Authorized Field Change

AFC G-01907

Subject: Mounting Bolt Replacement for Driver and Passenger Side Cab Entry Steps on 4300 and 4400 Models Built Before April 11, 2001

Figure 1 Replace Four Mounting Bolts on Each Step

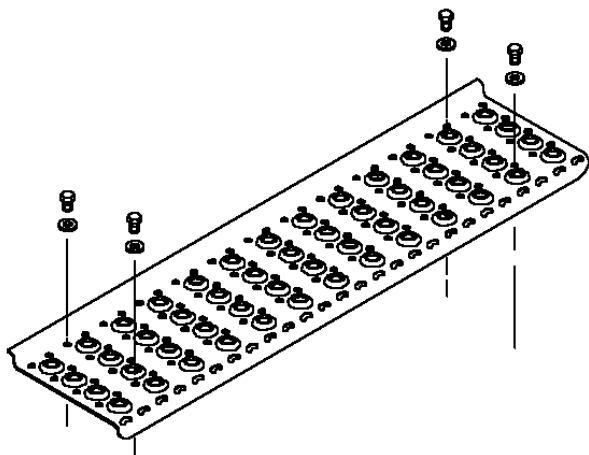
The cab entry step mounting bolts used on 4300 and 4400 Models built before April 11, 2001 have reduced thread engagement which may result in the cab entry steps rattling during operation.

1. Remove and replace the 4 cab entry step mounting bolts on each step (Figure 1) with the bolts from Kit Part Number 8000822R91. Re-use the current U-nut when replacing bolts.
2. Tighten the bolts to 174 to 212 Lbf-in (19.6 to 24 Nm).
